The Non-Scheduled Meeting of the Holiday Lake Rural Improvement Zone Trustees was held at 6:00 P.M. on Wednesday, July 19th, 2023, at 5043 Lakeshore Drive and 3054 Lakeshore drive. The meeting was called to order at 6:05 pm by President, Brad Storm.

The purpose of this meeting was to discuss storm water runoff problems and a under road culvert replacement.

5043 Lakeshore Drive: Stormwater Runoff

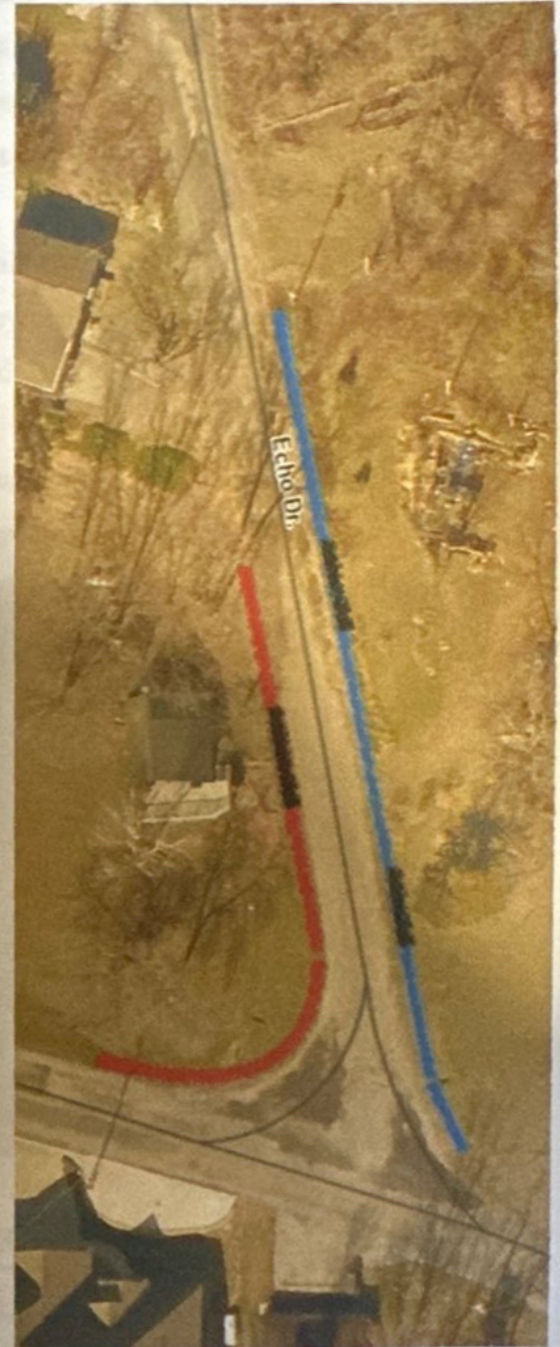
There was a RIZ trustee consensus to obtain a quote from Fass Excavating to construct the following to control the storm water runoff coming down Echo Drive.

1. Install a road side ditch lined with erosion stone on the west side of Echo Drive as drawn in red on the drawing with one driveway culvert drawn in black. The ditch shape and depth have to be determined by contractor.
2. Clean out and reshape the east side of Echo Drive as drawn in blue and install two new driveway culverts and line the ditch with erosion stone. The ditch shape and depth have to be determined by contractor.
